DESIGN REVIEW APPLICATION | DESIGN ADJUSTMENTS

SGA PROJECT NO. 20-119

Design Review Application **DR-23-01**
Design Adjustments in Response to
Comments from June 13th HRB Meeting

DESIGN REVIEW APPLICATION | DESIGN ADJUSTMENTS – PART 2

Figure from Section 58.080.C.3

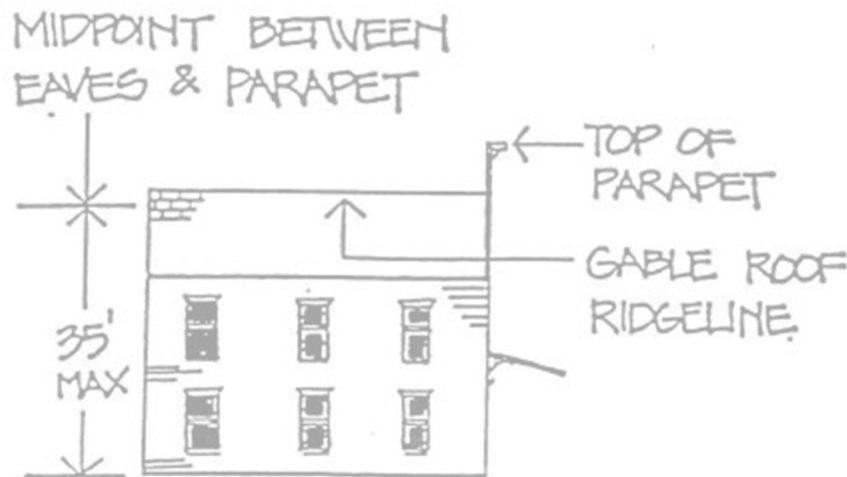
SECTION 58.080.C.3: "Building height limitations. Maximum building height shall be 35 feet (as measured by this code), and two stories. A false front shall be considered as the peak of the building if it exceeds the gable roof ridgeline."

- The above Code sections establish that the 35' maximum height occurs at a point midway between the eave and the top of the parapet (in our case, without a gable roof, the flat roof is the eave line). A heavy dashed red line is shown on the Willamette Falls Drive elevation 35' above the adjacent sidewalk grade 5' from the building. As shown, this line is at the top of the parapet across the entire elevation, and therefore is well above the allowable midpoint between eave and parapet. For clarity, we have also shown a heavy dashed red line indicating the flat roof (eave) line behind the parapet to further emphasize that we are fully in compliance with the standard.

1 GROUND FLOOR PLAN + WILLAMETTE FALLS DRIVE ELEVATION

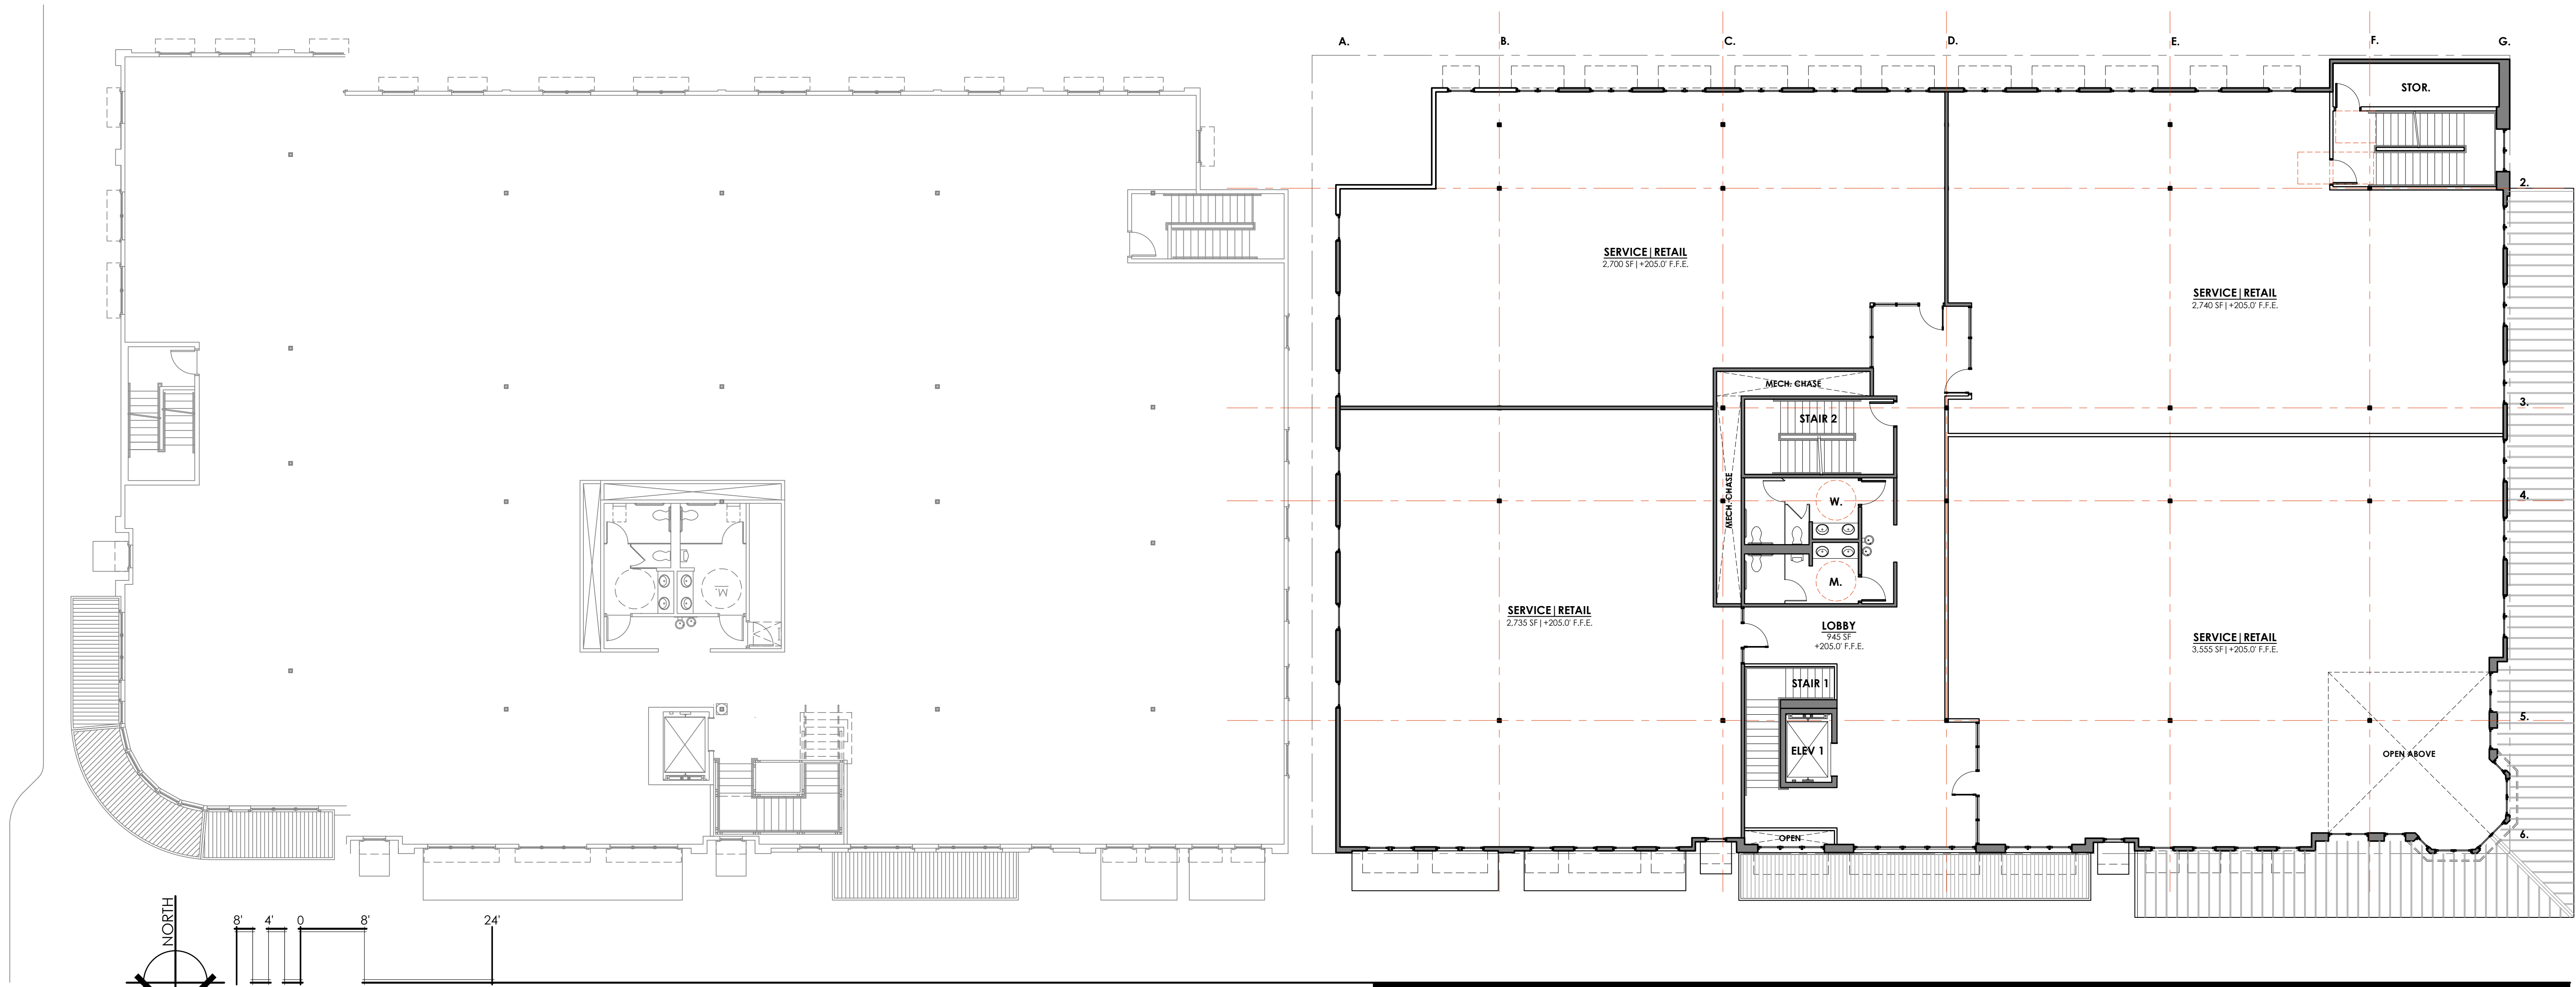
3. CONCERN: The Board was concerned that the drawing showing the Willamette Falls Drive elevation did not show clearly enough that the building elevation meets the 35' height limit required by the Standards. Per Section 41.005 "Determining Height of Building" and Section 58.080.C.3 of the WFDCD:

WEST (12th STREET) ELEVATION

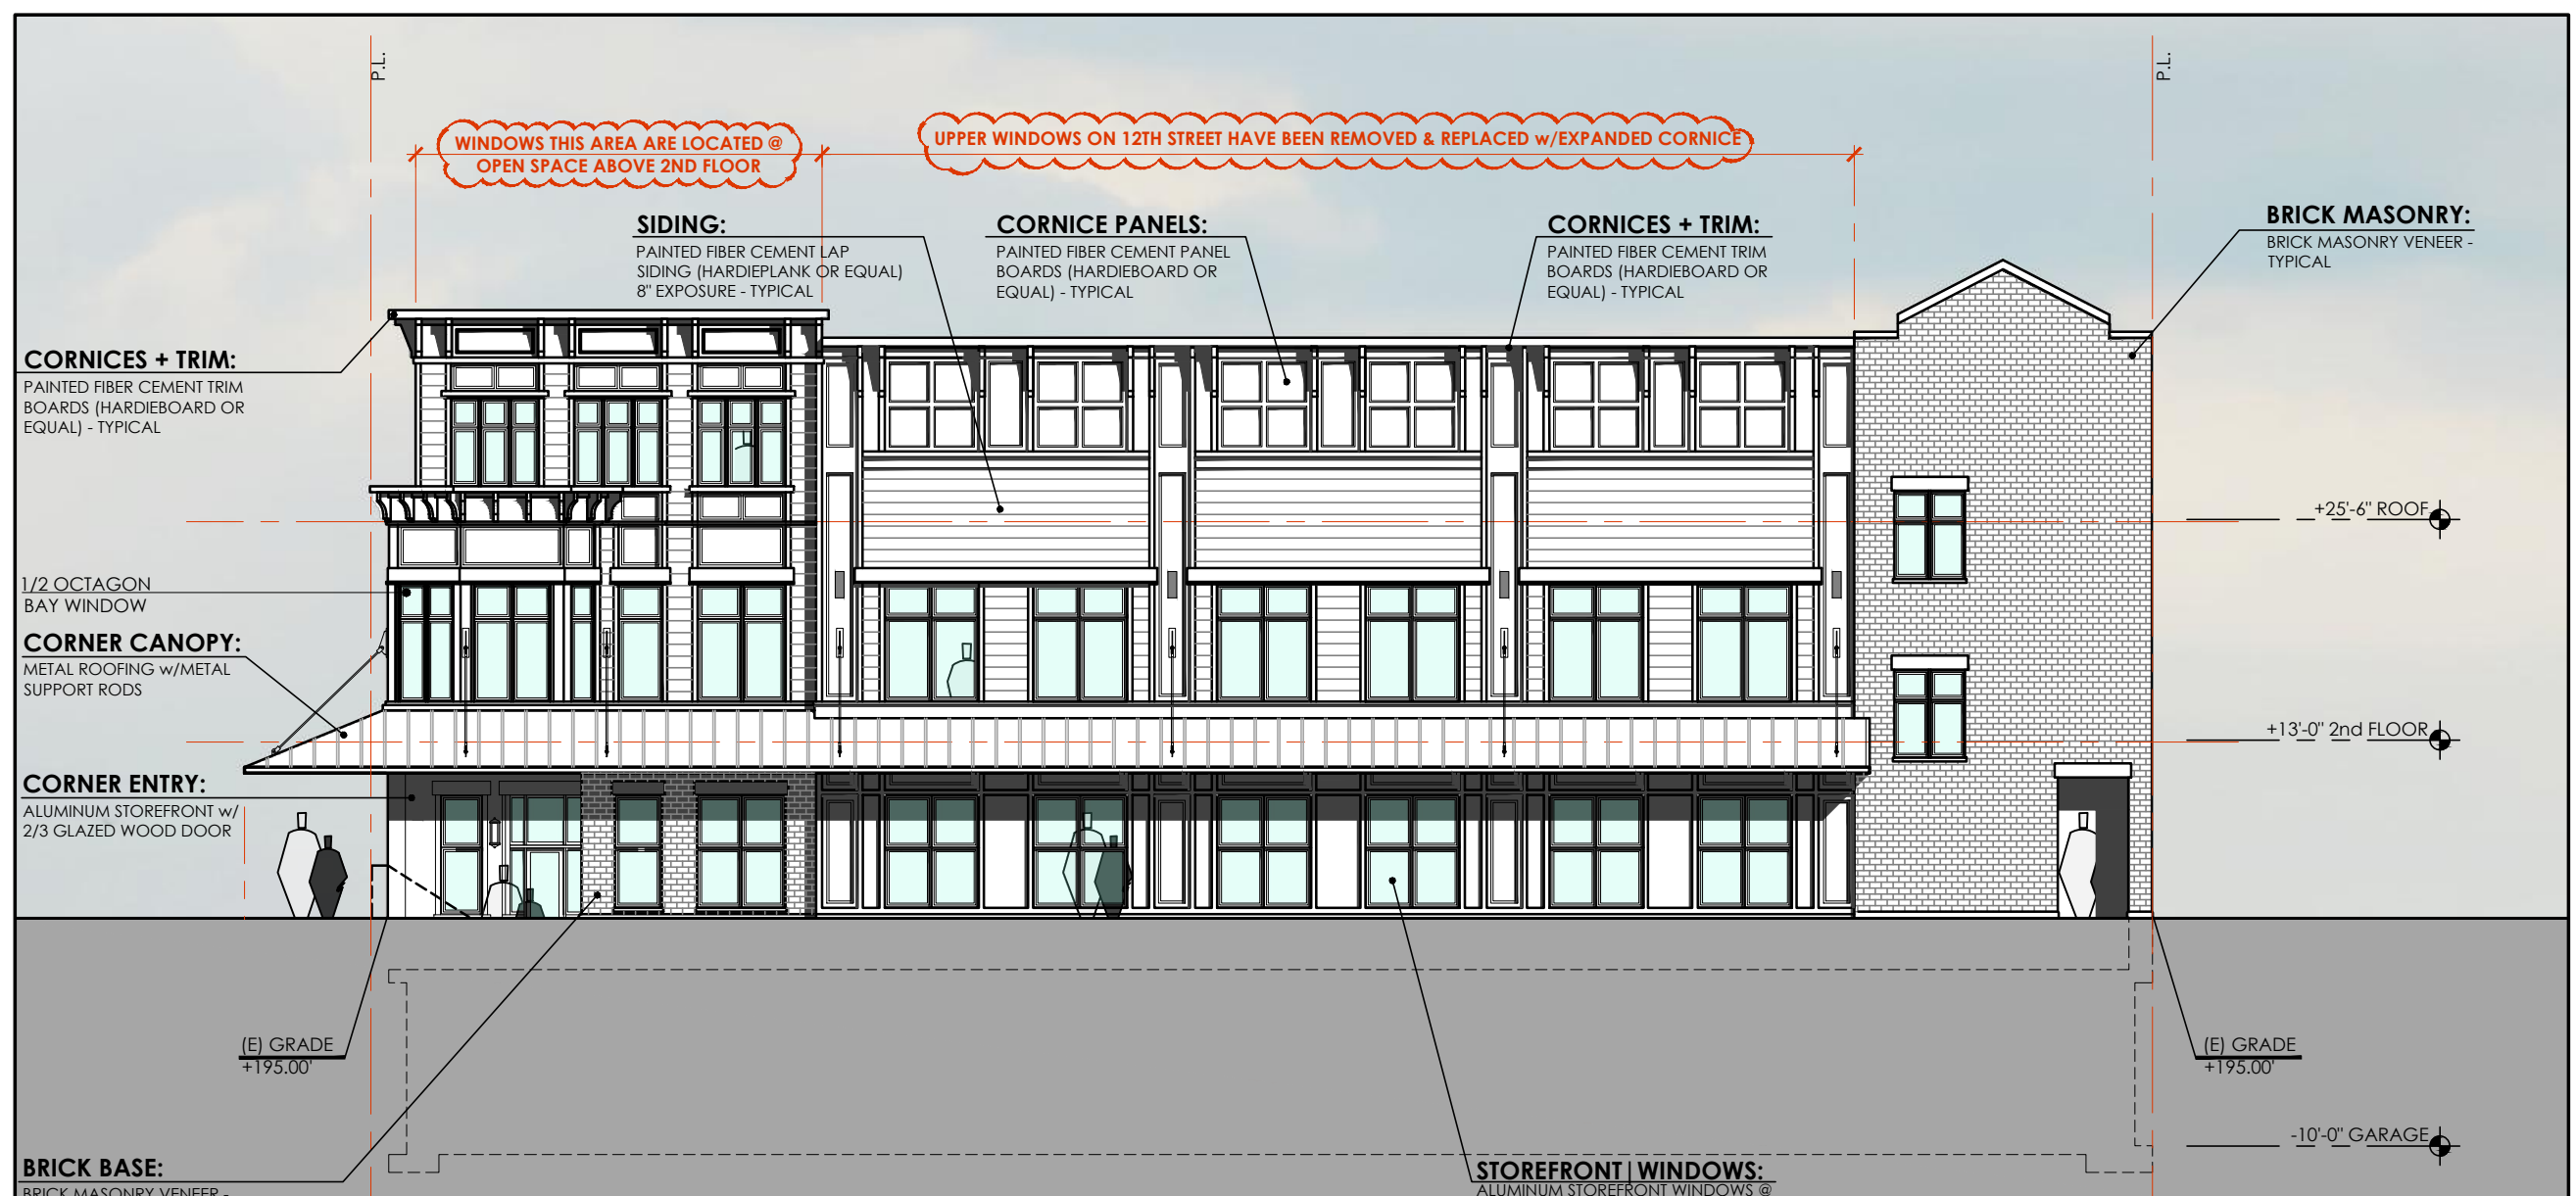
1. *CONCERN: While the IBC does not consider a mezzanine to be a separate floor, the HRB was not clear if the Willamette Falls Drive Commercial Design District Code (Chapter 58) (WFDCD) would allow for a mezzanine level above the second floor as shown in the 6/13 presentation. Further, the upper row of windows along 12th Street in the original presentation was seen by some as an indication of a 3rd floor that would not be permitted under the standards.*

- **The windows along 12th Street have been replaced with a redesigned cornice and vertical trim pilaster detail that matches closely to the design details along the front Willamette Falls Drive elevation. This was modified to break up and fill in the wall area where the windows were originally shown. Note that the uppermost windows at the northwest corner of the building remain, shedding natural light into a double height atrium-style space above the second floor.**
 - **We have repurposed the enclosed rooftop spaces to be used for storage and mechanical equipment use.**
 - **The outdoor roof deck remains for general use.**
2. *CONCERN: There was concern from the residential neighbors across Knapps Alley that the 2nd floor windows on the alley elevation were too large.*

02 WILLAMETTE FALLS DRIVE - 1949 WFD ROOF DECK PLAN

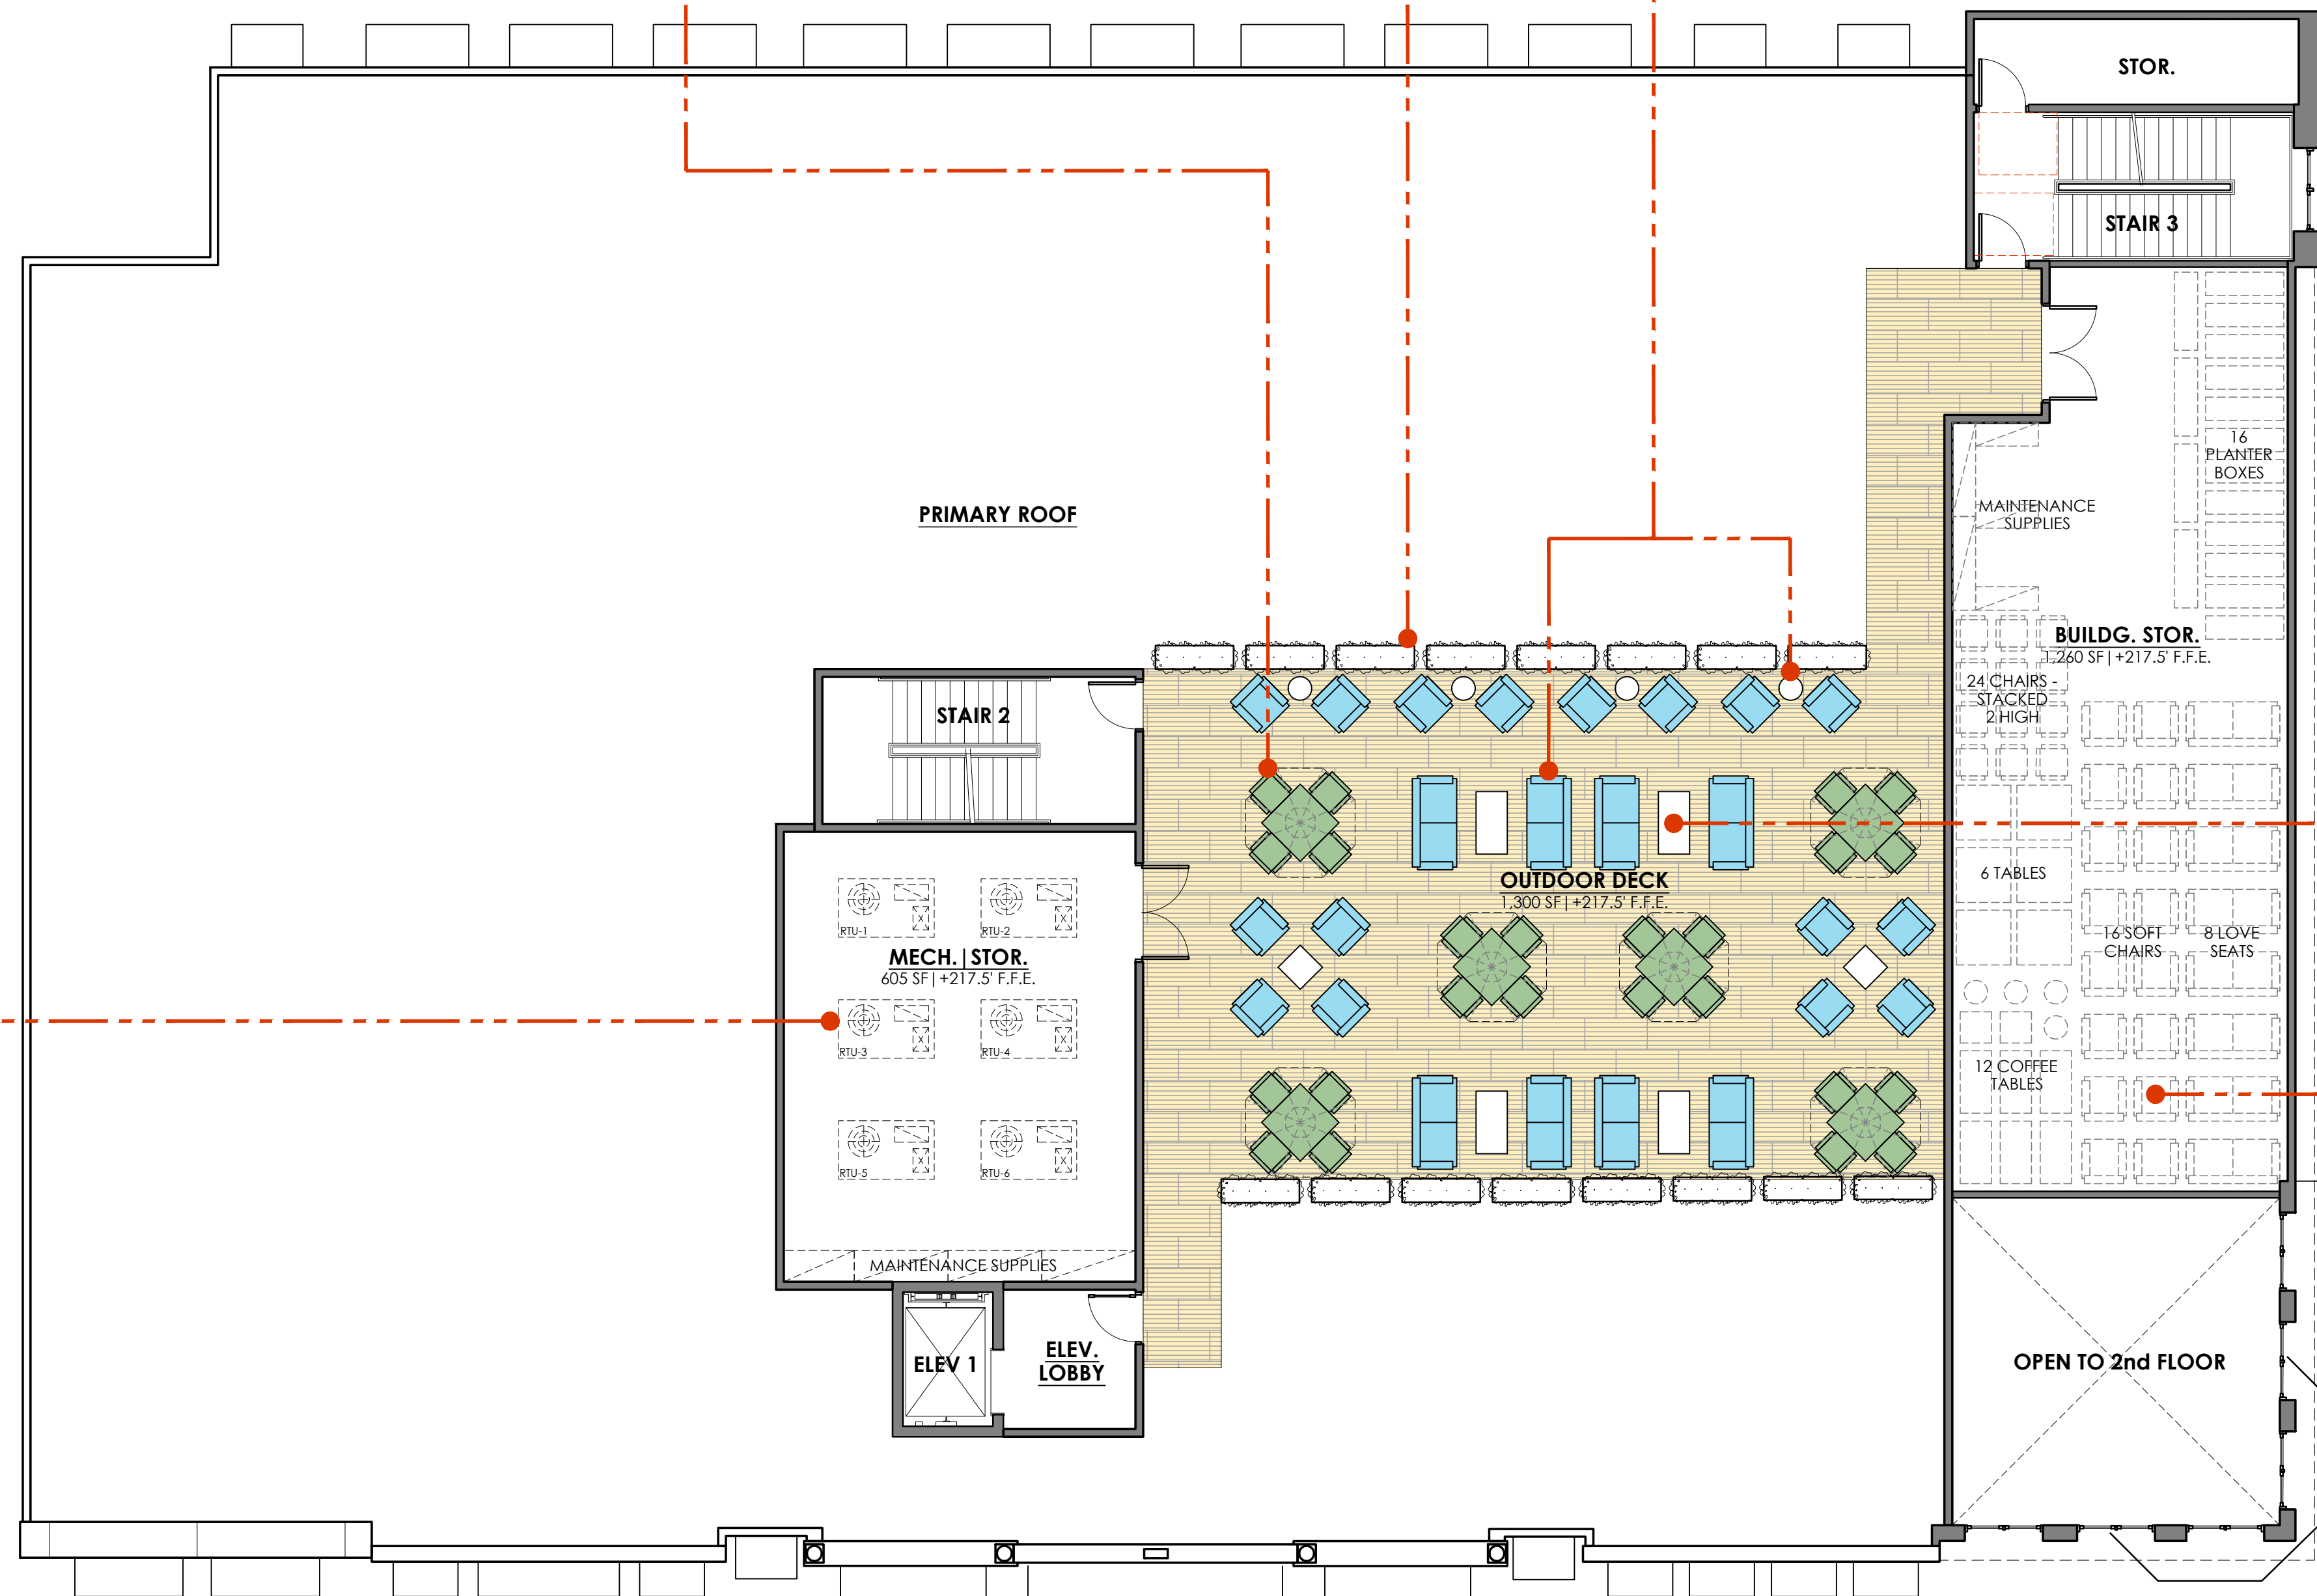
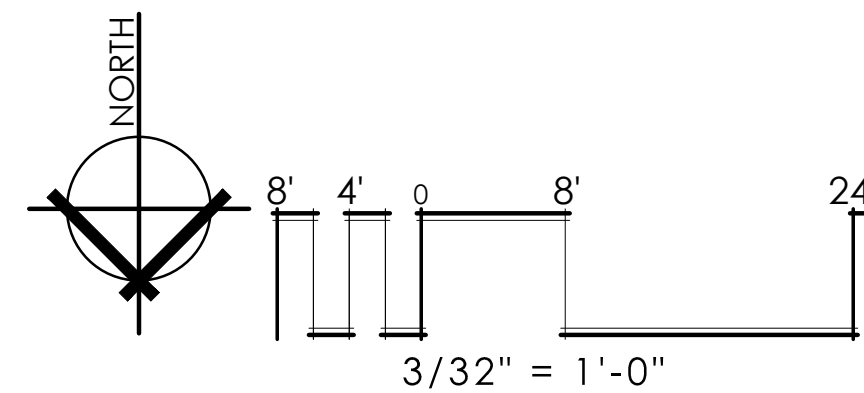
PART 2: In the previous submittal, the windows along 12th were removed and the cornice line adjusted, and the enclosed roof top spaces were revised to be un-conditioned and unoccupied storage and mechanical spaces. Nonetheless, Staff remains concerned that those enclosed spaces still constitute a third floor.

In the proposed 1949 building, the enclosed spaces will be un-conditioned and unoccupied. They will house mechanical equipment, store furnishings from the outdoor deck, and provide needed additional general building storage. The spaces will be fully hidden from view behind the Willamette Falls Drive and 12th Street facades. The stairs and elevator extend from the lower floors to allow roof and deck use, maintain the roof and roof equipment, and provide Code required access to exit routes.
